## Permitting Decisions- Variation

We have decided to grant the variation for West Meadows Waste Recovery Facility operated by 2ZLF Limited.

The variation number is EPR/AB3904UQ/V005.

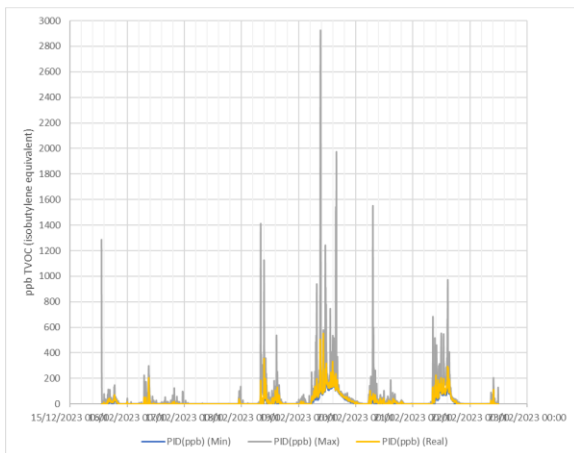
There is a shallow reception pit at 2ZLF into which the arriving waste vehicles tip their gully and street cleaning wastes before on-site treatment.

It would appear that this offloading area, referenced within 2ZLF as the ‘wet waste unloading bay’, may constitute a storage pit which the Appropriate Measures say, as a rule, should not be used. The bay is not lined with any impermeable membrane.

The risks from use of this pit would be diffuse emissions of volatile organic compounds (VOCs) which can cause odour.

The operator submitted further justification for the use of this pit during the determination of the application. They installed static monitors at a number of locations around the wet waste unloading bay. They also installed for a period of sampling, a continuous monitoring system for total VOCs.

Based on these analyses, we have agreed that the operation of the unloading pit can continue. We have included an improvement condition, IC2, requiring 2ZLF to investigate the installation of leak detection in the bay to help prevent any releases of pollutants to soil and/or groundwater.
